**MEMORANDUM**

**Subject:** Site Plan Special Permit/Use Special Permit Application #11/20/15 - 459

Location: 180-182 Skyline Drive  
Map/Parcel: C4-14 & 32  
Applicant: Town of Concord  
Owner: Town of Concord  
Engineer: Environmental Partners Group, Inc.  
Previous Site Plan & Use  
Special Permit: #08/25/94 - 346  
Zoning: Single Family Residential (R-8 & R-10/8)  
Groundwater Protection Districts Zone 4  
Lot Area: +/- 60 acres  
Proposed Net Floor Area: +/- 9,300 square feet  
Existing/Proposed Uses: Concord Municipal Water Treatment Plant, Nagog Pond  
**Hearing Date:** **01/25/16**  
**Continued Hearing Date:** **09/12/16**  
**Decision Due:** ~~04/24/16~~ **12/11/16**

### The floodplain

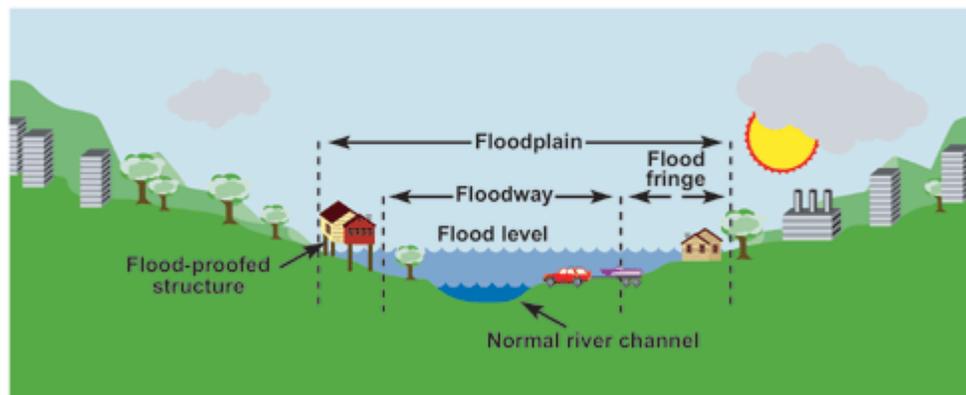
9. *The proposal now includes a fence for a long section of the property line (quotations below are excerpts from the Acton Zoning Bylaw).*
  - a. *The Acton zoning bylaw allows property line fences up to eight feet in height; if higher the fences must meet setback requirements for structures, here that is 20 feet.*

- b. *A portion of the proposed fence would traverse a 100-year flood plain. The Acton zoning bylaw regulates uses and activities in the flood plain; some are allowed by right, others require a special permit.*

- e. A portion of the fence traverses the Nagog Brook floodway. The Acton zoning bylaw prohibits most uses and activities in the floodway, including the construction of a fence, unless “(a) a technical evaluation by a Registered Professional Engineer demonstrates that the new construction or encroachment will not result in any increase in flood levels during the occurrence of the Base Flood discharge; (b) and it is otherwise allowed by a special permit from the Board of Appeals under Section 4.1.8” (s. 4.1.4).

- i. The applicant has not provided the PE evaluation under part (a).
- ii. Part (b) refers to special permit criteria and requirements within the floodway fringe for which footnote 4 of the Table of Principal Uses gives authority to the Board of Selectmen, for purposes of the subject application.

- iv. However, the application is missing the technical data back-up required under sections 4.1.4 (P.E. evaluation), 4.1.8 (maintain 98% flood storage volume, compensatory flood storage area, flood resistant materials and construction methods, etc.), and 4.1.9 (P.E calculations and certifications).

- f. A portion of the fence traverses the Nagog Brook floodway fringe. The Acton zoning bylaw allows certain uses and activities in the floodway fringe by right, including the “construction, maintenance and repair of municipal and private water supply structures” (s. 4.1.7.3). I deem the proposed fence to be such a structure.
